PCN – Product Change Notification

Document No	PCN-A-080610	Revision	1.0		
-------------	--------------	----------	-----	--	--

ECN Topic: New 20.1 inches network player MSS300 CH new dimension

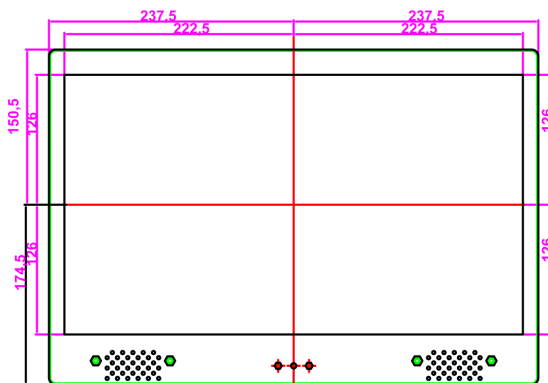
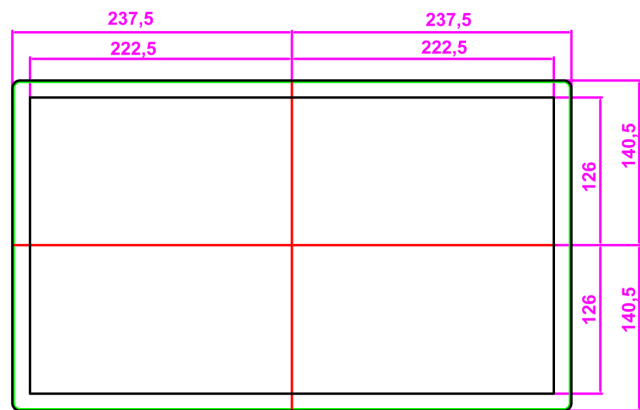
We will use a new 20.1 inches network player MSS300 CH. We change the location of SPK & IR from the front side to back mechanic. The dimension of chassis will change to 475 x 282 mm from 475 x 325 mm.

The below pictures show the example of how the new mechanic differ from Original one.
